Accessibility Survey

Alameda Street & Birchdale Avenue

Date of Inspection
3/17/2017

Disability Access Consultants

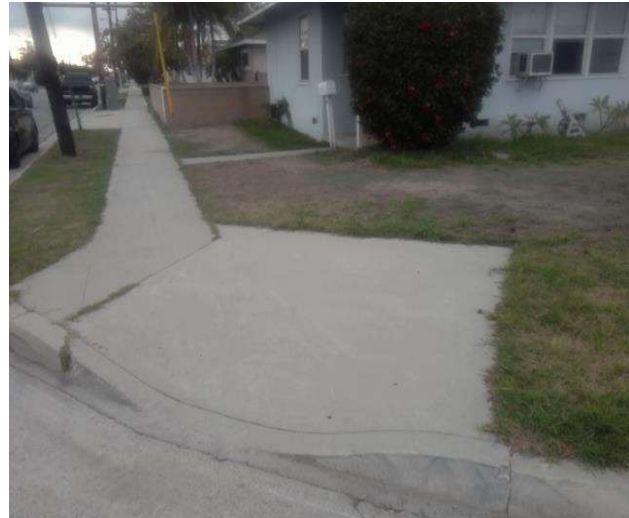
The running slope is greater than allowed.

On-Site Finding 12.60 percent

Provide a compliant curb ramp.

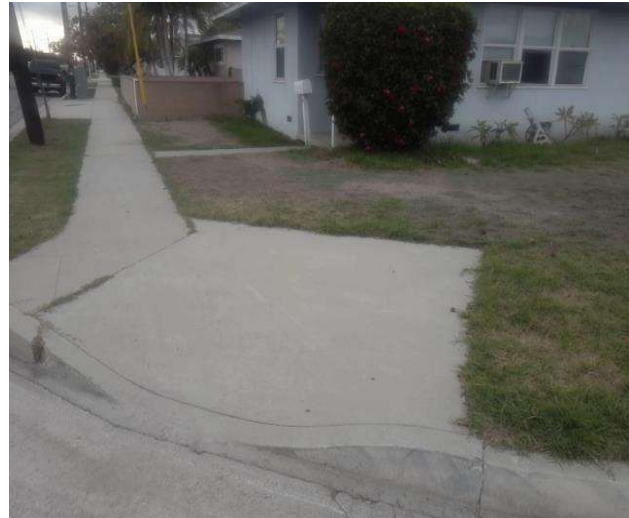
There is not enough top landing clear length.

On-Site Finding 0.00 inches

Provide a level top landing with enough clear length.
